**RESOLUTION NO. 2017-27**

**A RESOLUTION OF THE LOWER PROVIDENCE TOWNSHIP BOARD OF SUPERVISORS, MONTGOMERY COUNTY, PENNSYLVANIA, APPROVING THE PRELIMINARY/FINAL SUBDIVISION AND LAND DEVELOPMENT PLAN FOR LIDL US FOR A PROPOSED GROCERY STORE AT 2601-2614 RIDGE PIKE**

RE: **Traffic Review #2 – Transportation Impact Study/Partial Plan Resubmission**  
Proposed Lidl Discount Supermarket [Ridge Pike (SR 0363) and Trooper Rd (SR 3002)]  
Lower Providence Township, Montgomery County  
McMahon Project No. 817300.11

SUBJECT: **REVIEW COMMENTS – LIDL US**  
**SUBDIVISION AND LAND DEVELOPMENT PLAN DATED JULY 26, 2017; AND**  
**REVISED SITE PLAN AND LANDSCAPE PLAN DATED SEPTEMBER 8, 2017**

**2.A Five (5) Rectangular Planters Near the Concrete Entrance Apron**

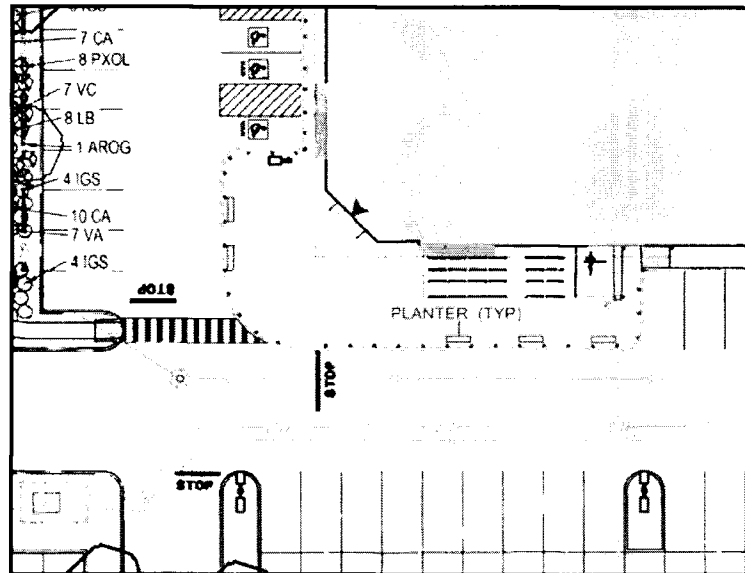
**With this context in mind, several potential approaches to achieving the additional aesthetic and functional objectives of the foundation planting requirements have been discussed with the Applicant Team. Subsequent to these discussions, we believe that it may be appropriate to consider the following options:**

Five (5) low rectangular planters (approx. 1.5 feet wide x 6 feet long x 1.5 feet high) could be installed in the locations pictured below. They could be planted with low-maintenance ornamental grasses, such as Blue Fescue (*Festuca glauca*).

In addition to enhancing the appearance of the entrance area, we believe that such planters would help to channel pedestrian traffic between the entrance and parking spaces, thereby providing more visual predictability for motorists. On the other hand, we do not believe that such limited planter installation would degrade pedestrian convenience.
